**FINAL**  
**YEAR 4 (2017) MONITORING REPORT**  
**UT TO MARTIN'S CREEK (CONTRERAS) MITIGATION PROJECT**  
Cherokee County, North Carolina  
DMS Project No. 92766 (Contract No. 005717)  
USACE Action ID No. 2010-00961/DWR Project No. 2010-00448  
SCO No. 08-07249-01

RE: UT to Martin's Creek (Contreras) Monitoring (DMS Project # 92633, Contract # 005717)  
Final MY4 (2017) Annual Monitoring Report

Axiom Environmental, Inc. (AXE) is pleased to provide you with three hard copies and a CD of digital files for the Final UT to Martin's Creek (Contreras) Annual Monitoring Report. We received your comments via email on November 28, 2017 and have addressed them as follows:

FIGURE  
**2**

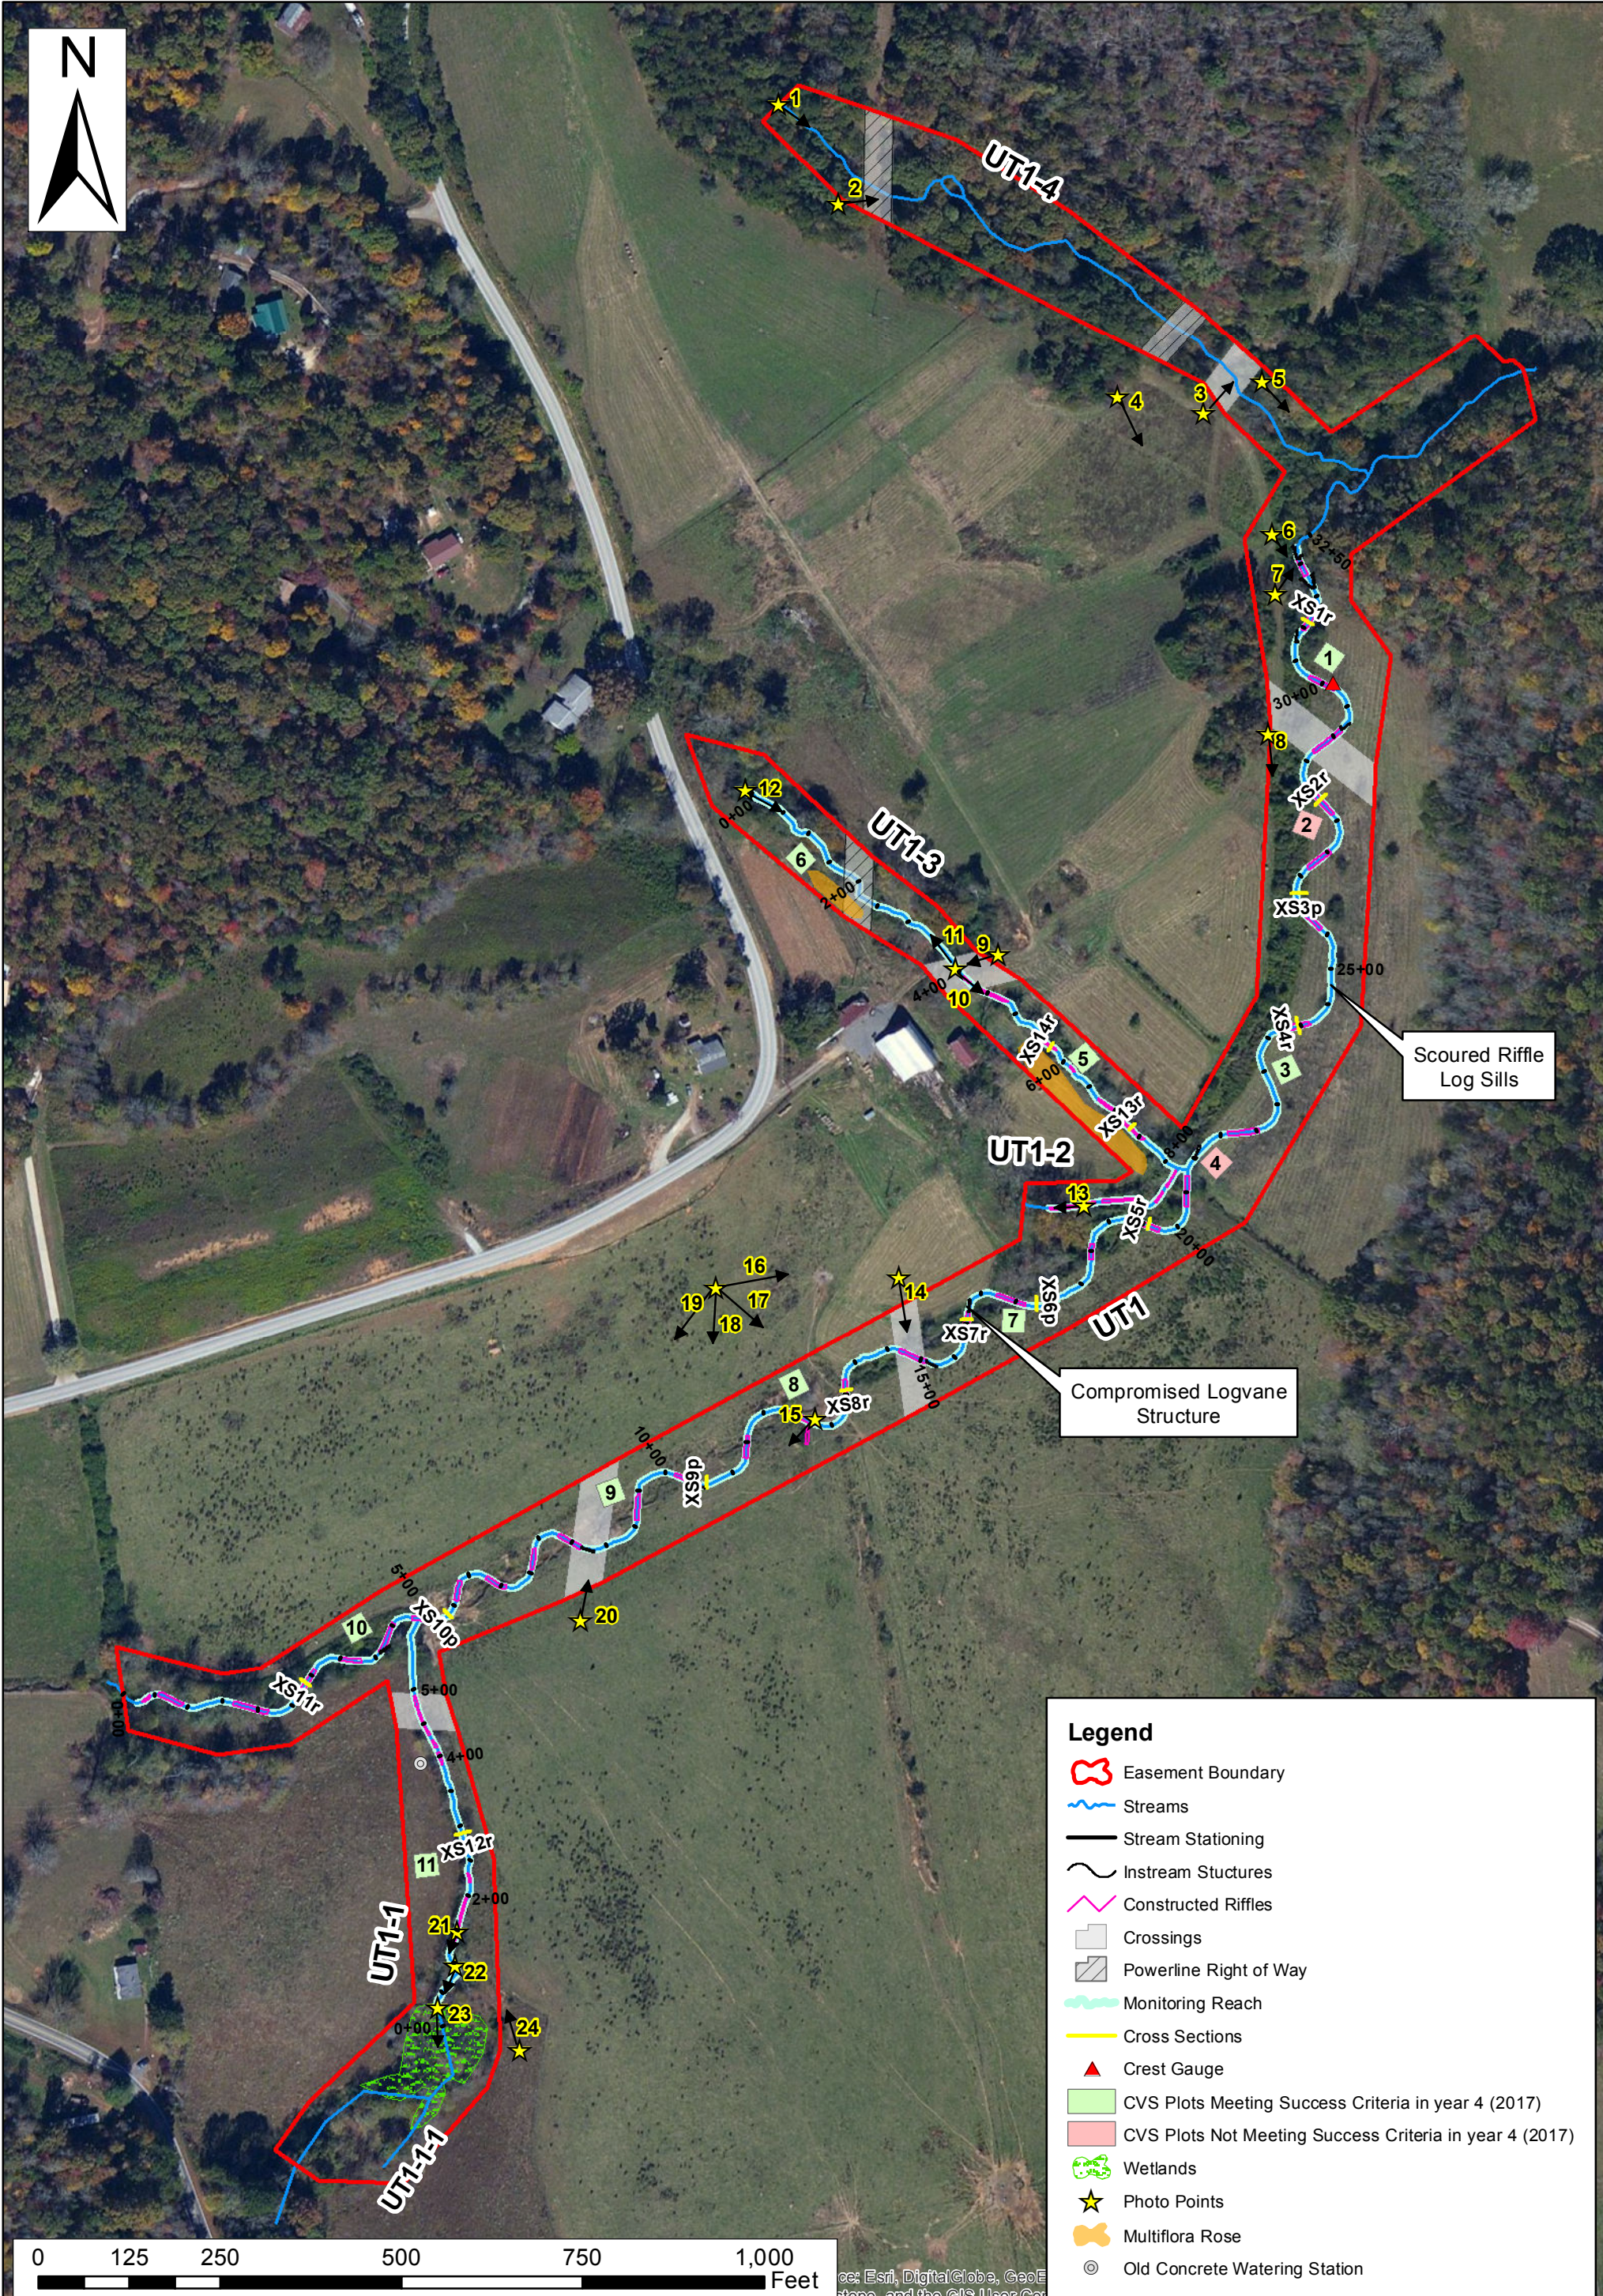
**2.1 Streams:** The two areas of concern noted along UT-1 were identified during the MY3 report. Are the areas trending toward stability, unchanged or becoming worse? Please update the discussion with current site specific information. I would rather not say they are likely to fail if the structures have remained unchanged over the past monitoring year.

*The stream areas of concern discussion was revised to read as follows: "Two areas of concern were noted along UT-1 during Year 3 (2016), and both remained relatively unchanged during Year 4 (2017). One area consists of a section of log sills constructed within a riffle near station 25+00. The riffle bed material surrounding the log structures has scoured resulting in pools through this section of stream. This issue was first identified during Year 3 (2016), and it continues to appear unstable; however, it has not worsened significantly in the past year which may indicate more stability than originally assumed. An additional area of concern includes a log vane structure along the right bank of UT-1, just downstream from cross-section 7. The footer log of the structure has failed and become partially dislodged, and the downstream end of the log appears to move freely with the flow of the stream. However, it has continued to maintain grade along the upstream riffle, and it appears to be in a similar state as it was originally observed. Thus, the structure may be more stable than was reported during Year 3 (2016)."*

*It is our opinion that both structures could potentially fail given a significant (3+ inch) heavy rain event (which we have not had to date in 2017). However, the fact that the areas appear relatively unchanged this year when compared with 2016 may mean that they are more stable than we originally reported.*

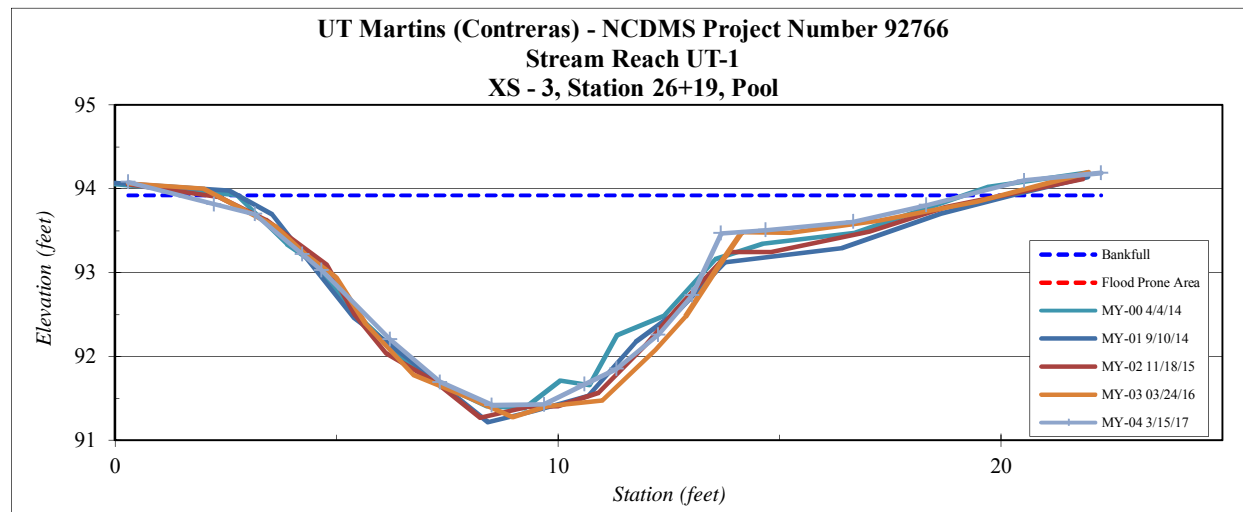
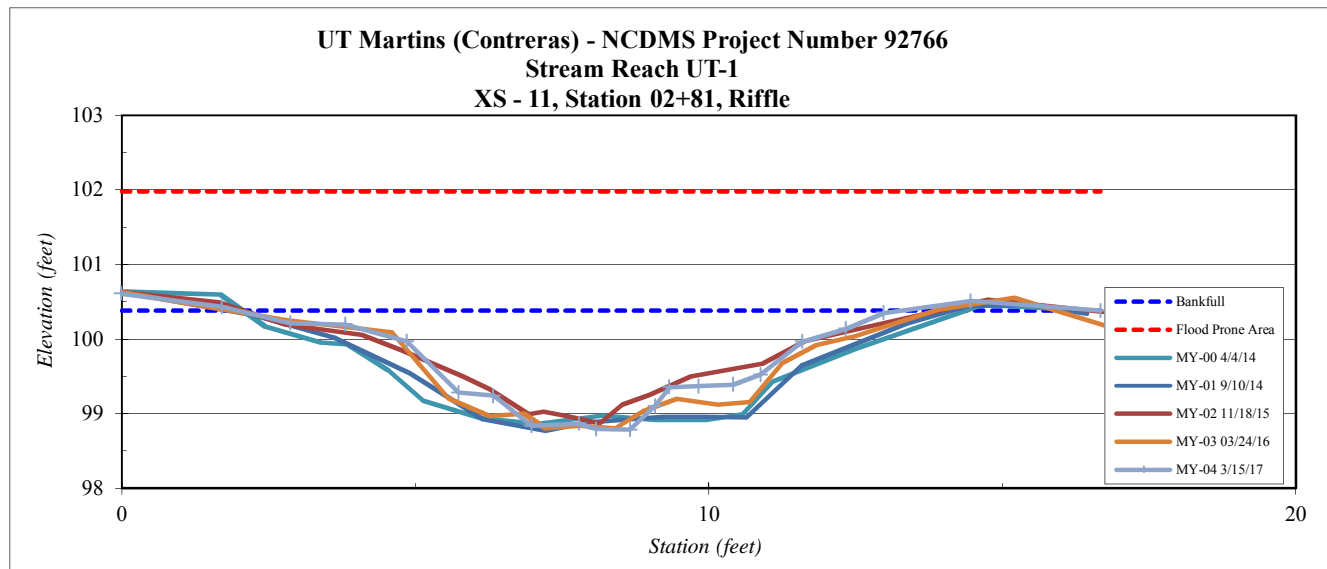
**Cross Sections and Table 11:** The IRT has requested that Bank Height Ratios be calculated. Please calculate BHR for x-sections and update Table 11.

*The bank height ratio was recalculated for all cross-sections, and since no cross-sections have exhibited any stream bed elevation change during the monitoring period, all cross-sections have a bank height ratio of 1.0. This indicates minimal geomorphic change and good cross-sectional stability across the site.*
